**LONDON LUTON AIRPORT EXPANSION DEVELOPMENT CONSENT ORDER  
APPLICATION**

**ISSUE SPECIFIC HEARING 6 DEALING WITH MATTERS RELATING TO  
BIODIVERSITY, WATER, LAND-USE, LANDSCAPE AND VISUAL, DESIGN AND  
HERITAGE.**

**POST HEARING SUBMISSION FOR CENTRAL BEDFORDSHIRE COUNCIL**

**Fig.3. Central Bedfordshire Council Notes (N) on ES Statement Chapter 14 Fig.14.8 Viewpoints in respect of Someries Castle, Luton Hoo RPG parkland and land beyond to the northeast. Notes (N): N1 and N2: Additional requested AVR Viewpoints towards application site, Hog Trough valley.**

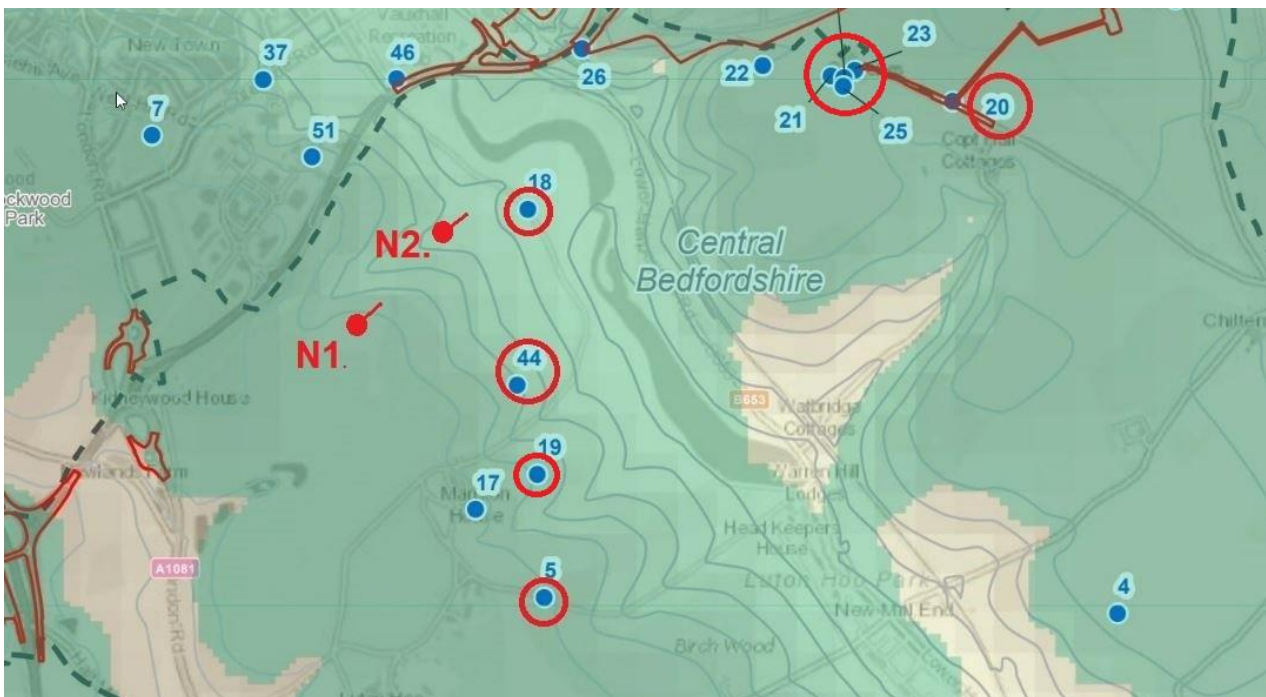
Central Bedfordshire Council considers that Accurate Visual Representation (AVR) Viewpoint 19 (Luton Hoo Parkland) [AS-142] is insufficient to understand the potential impacts of the proposed development.

Two further AVR viewpoints are put forward (referenced as N1 and N2 on Fig. 3 below), and it is requested that Assessment Viewpoint Location No.44 (Stockings Wood), as shown on Fig.14.8 in ES Statement Chapter 14 - document TR020001-001084-5.03 (Revision 01), but mislabelled as 'Stopsley Wood', is included as an AVR photo montage, for complete clarity.
